The Great Grid Upgrade

Norwich to Tilbury

Design Development Report

Addendum for Proposed Changes to Connection at Tilbury

Figure 2 - Plan showing the proposed amended change of connection at Tilbury

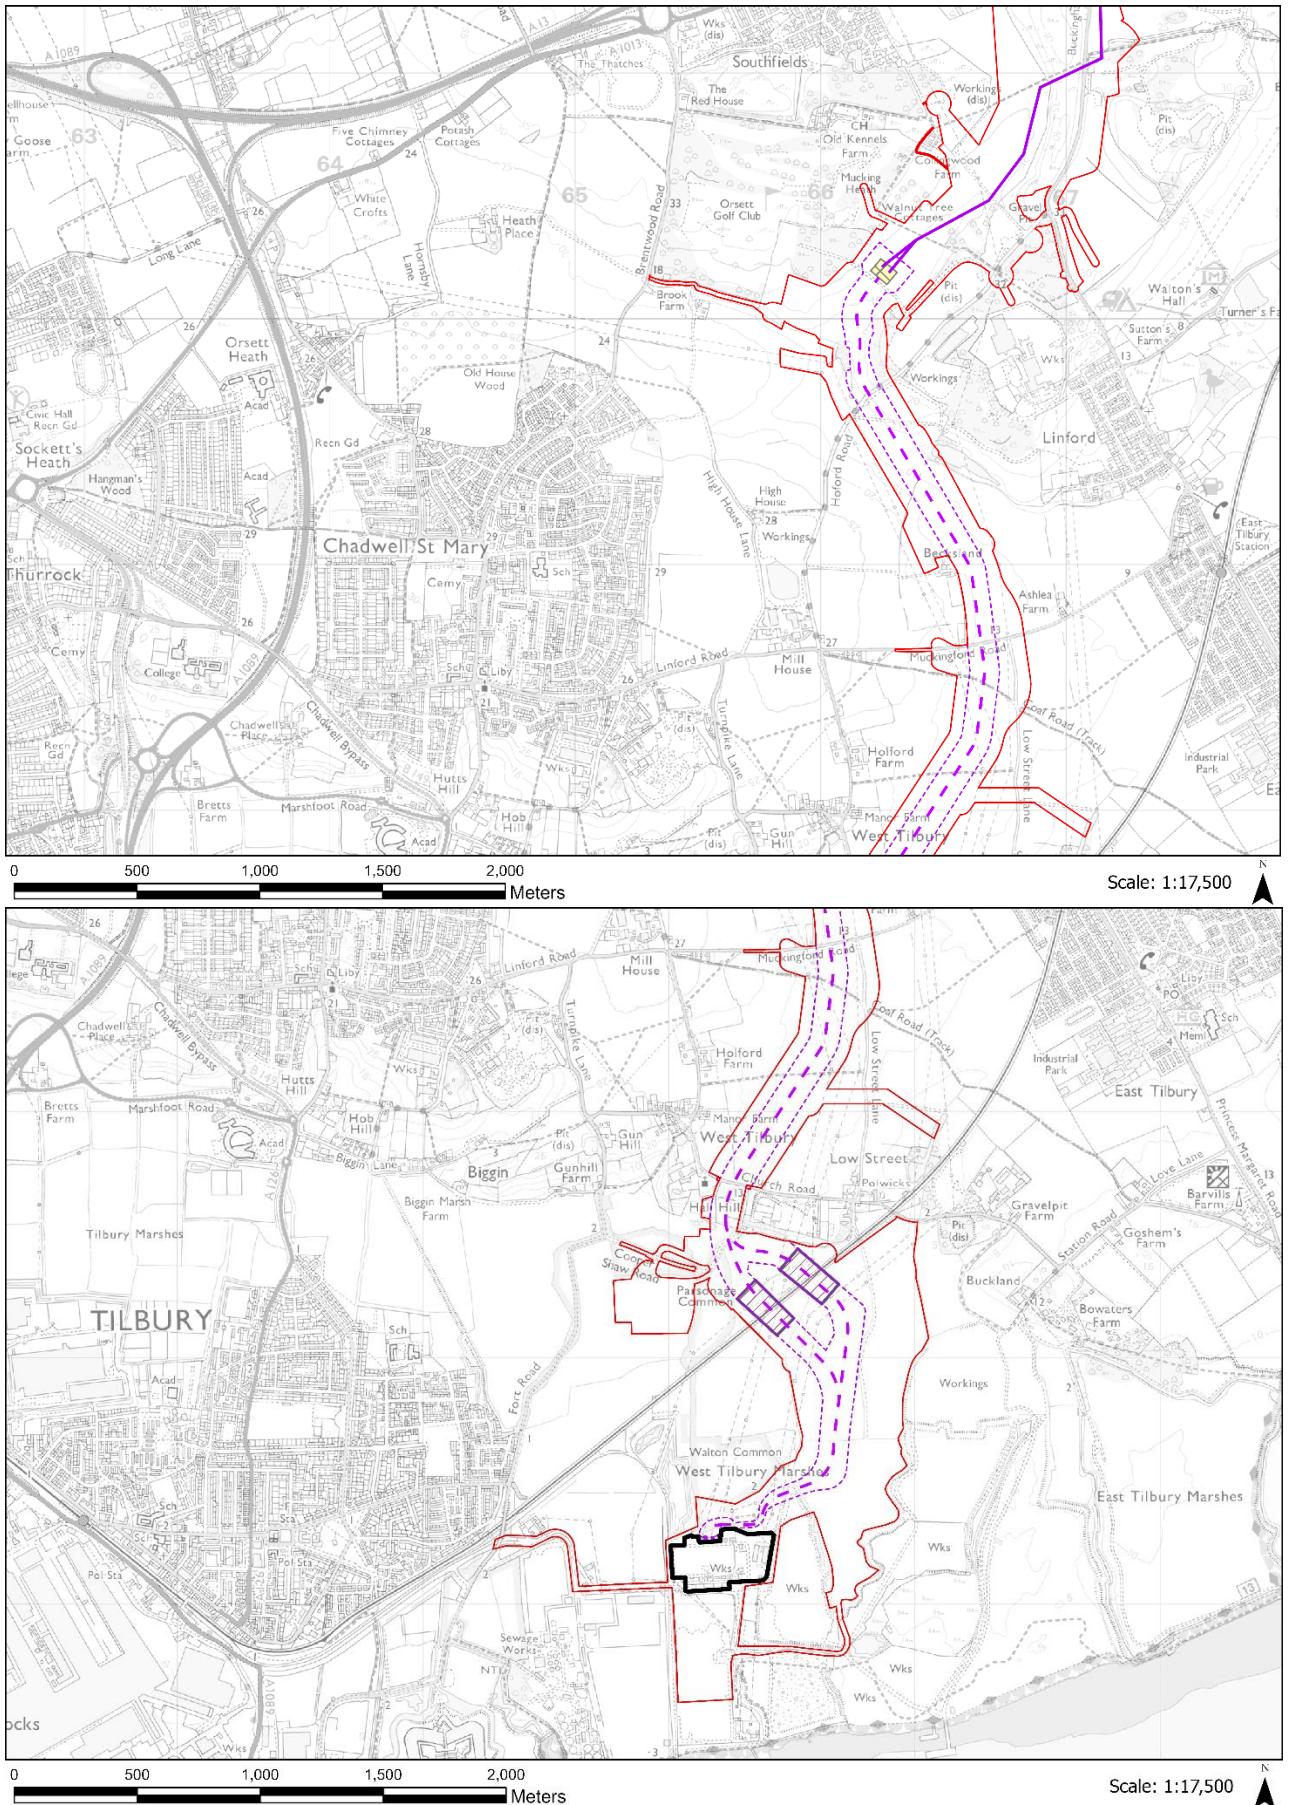
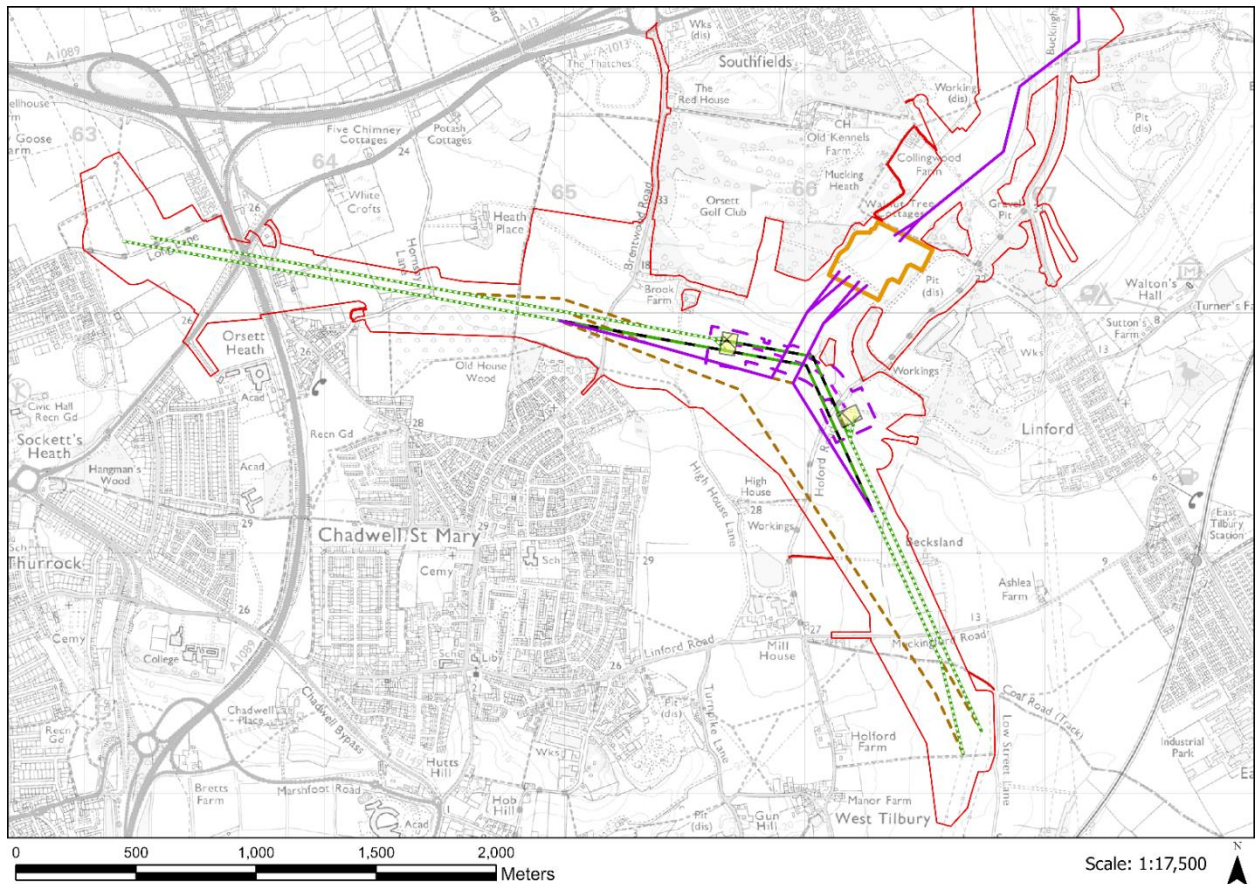
- 1.2.5 Plans showing the general arrangements of the connection into Tilbury at statutory consultation are shown below (Figure 1). A summary of the main changes follows (Figure 2).

1.2.6 The main changes proposed are as follows:

- Change to the Connection arrangement for the Norwich to Tilbury Project, changing it from the installation of a cable sealing end compound and new cable connection to Tilbury Substation to a new substation and connection into, and use of, the existing overhead lines to the south of Orsett golf course to achieve the connection to Tilbury Substation. Change associated with:
 - change to proposed Order Limits including flexibility to reduce potential effects if Lower Thames Crossing project delayed or cancelled
- Removal from the Project of:

1.2.7 a CSE compound to the south of Orsett golf course

- 4.5 km of underground cable from the CSE south of Orsett golf course to Tilbury Substation
- Any remaining interaction and potential restriction to key economic growth centres at Port of Tilbury and Freeport amongst others
- Addition to the Project of:
 - a new substation referred to as Tilbury North to the south of Orsett golf course on the location of the removed CSE
 - Two CSEs to underground around 600m of the more easterly of the existing overhead lines

- Diversions to the south (by up to 100m) of the more westerly of the existing overhead lines along with new overhead line to connect to Tilbury North Substation
- Replacement of around 600m of the ZB overhead line with underground cable requiring two CSEs.
- Modification to the existing network for the purposes of connecting electrically into the existing Tilbury Substation:
 - the location of the overhead line crossing of Orsett golf course.
 - The arrangements to cross the proposed Lower Thames Crossing project from underground cable to overhead line
- Temporary use of land:
 - for temporary diversions of overhead line to maintain connections
 - to facilitate installation work e.g. green lines for re-stringing with no change to permanent assets
 - for construction access arrangements

Figure 3 – Tilbury North Substation Options

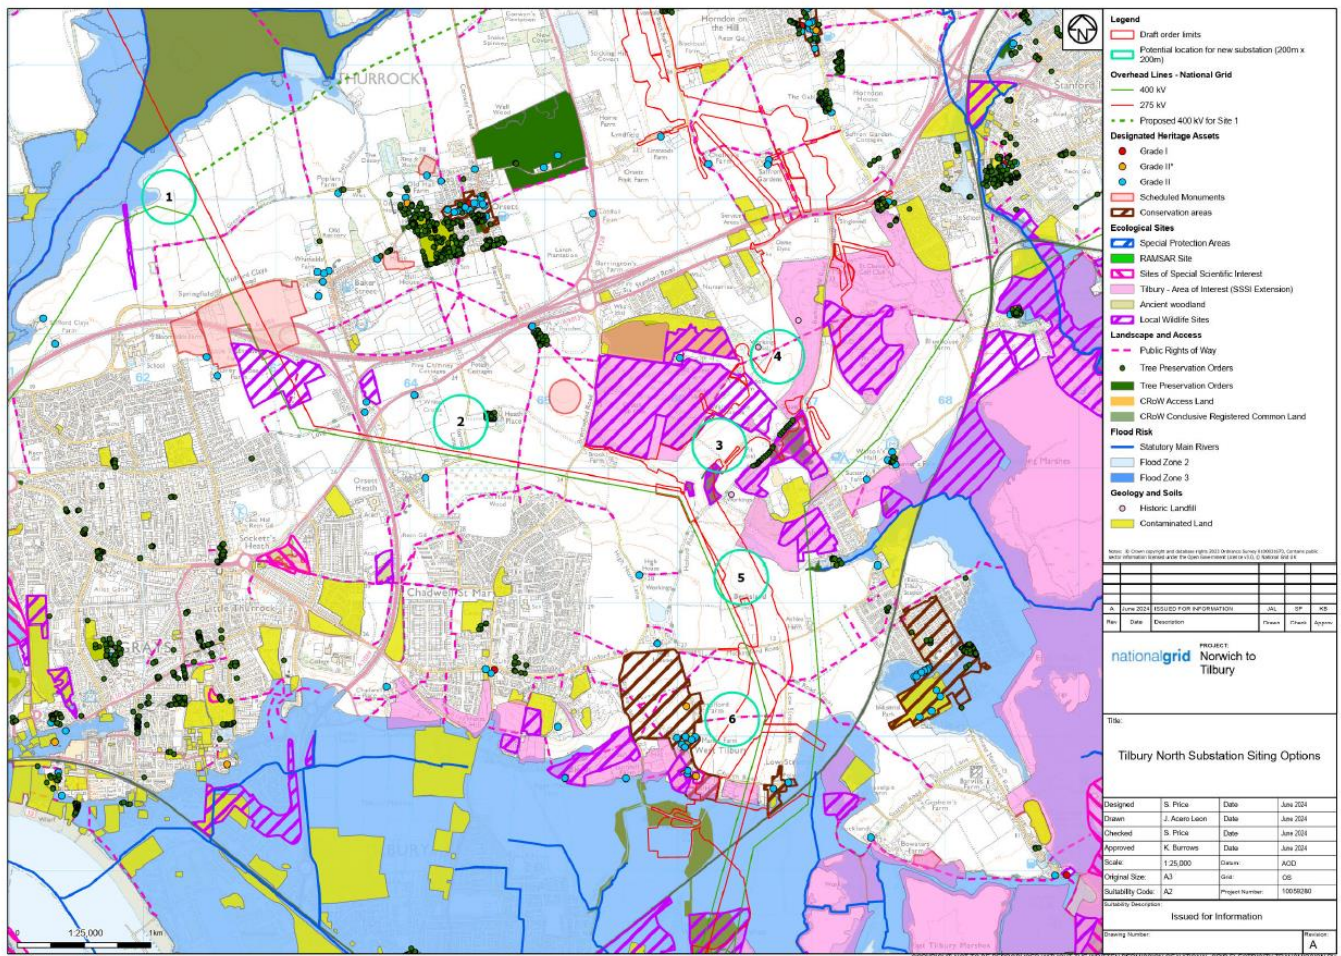
- 1.3.14 Locations both to the north-west (up to where the existing YYJ and ZB overhead lines diverge just north of the A13), to the south (through to Tilbury Substation) or to the north along the Norwich to Tilbury Project alignment were identified and considered. Indicative locations are shown on the image below (shown as numbered in turquoise coloured circles):

- 1.3.16 On this basis, Site 1 is scoped out of further consideration as the need to acquire survey data on various environmental and technical topics to inform design and necessary environmental assessment leads to an expected programme delay estimated to be in the order of 2 years, leading to an in service date beyond 2030 that would trigger high constraint cost payments. This fails to meet the minimum need case requirement and therefore Site 1 is not progressed.

- 1.3.17 Site 2 has major transport infrastructure to the north and potentially LTC to the west. The location has residential properties, listed buildings and scheduled monuments (near to Heath Place) to all sides. With any overhead line connection routes also having insufficient spacing between residential properties. These constraints alone may scope this site out as a preferred option but even if less constrained this site would, like Site 1, be scoped out because of the additional

- 1.3.18 All other sites are considered capable of meeting the need case requirement, but are also subject to benefit filter review.
- 1.3.19 Site 4 is assessed to lead to extra effects and costs compared with Site 3. These are expected to include similar effects on the housing allocation at Chadwell St Mary due to similar diversion requirements of the YYJ and ZB, but with additional effects, affecting a similar area of potential housing, on the Southfields opportunity area. The crossing of Orsett golf course would increase effects as a result of the crossing by two overhead lines. For these reasons Site 4 performs less well than Site 3 so Site 4 is not taken forwards.

- 1.3.20 Site 6, whilst potentially providing an alternative to Site 5, requires the additional cost of longer cables to reach the site including the additional complexity of an additional trenchless crossing under Muckingford Road. It potentially avoids effects on housing at Chadwell St Mary though does route through an area that may provide green space for that development. It is also considered to be a less economic solution than Site 5.

- 1.3.21 Following the above site identification and initial down-selection review, Sites 3 and 5 were taken forward for more detailed consideration.

- 1.3.22 The preferred Tilbury North Substation location is at Site 3. It presents some different technical risks due to the need for system outages, but these are within the scope of normal system management risks. In cost terms, compared with the design published in the 2024 statutory consultation, this change is expected to be broadly cost neutral. However, there is some uncertainty on such comparisons regarding the costs associated with securing necessary rights through the Freeport area (influencing the base case of the 2024 statutory consultation proposals) and Chadwell St Mary housing area if allocated (influencing the Site 3 costs). Additionally, the proposal does have technical benefit by virtue of the substation works being a substantially off-line build (unlike the 2024 statutory consultation proposals which are within an existing substation and requiring some decommissioning of operational assets) and overall presents less technical risk to delivery and to programme.

- 1.3.29 In conclusion, the preferred site for the proposed Tilbury North Substation is Site 3. This avoids the interactions around Tilbury Port, Freeport and their environs. It does however have potential to reduce the area potentially available for housing (as a result of how the connection to the YYJ line would need to be made) on land to the east of Chadwell St Mary being consulted upon for potential allocation in the local plan. Due to the layout of existing overhead lines, the ZB line (275kV) needs to be replaced, in part, by a short section of cable between new cable sealing end compounds. In the case of LTC progressing to construction, the space required for the CSE compounds, along with the constraints of the works associated with Lower Thames Crossing, will require a section of the YYJ to be diverted to the south and west deviating by up to approximately 100m from the existing YYJ alignment. The scale of interface may potentially reduce the development area by up to 8 hectares (within an estimated total allocation area of up to around 90 hectares) though this extent will only be confirmed once detailed design is completed and a reduced extent may well be achieved within Limits of Deviation. Even then it is anticipated that site masterplanning would further reduce the loss of housing land by repositioning of some land uses.
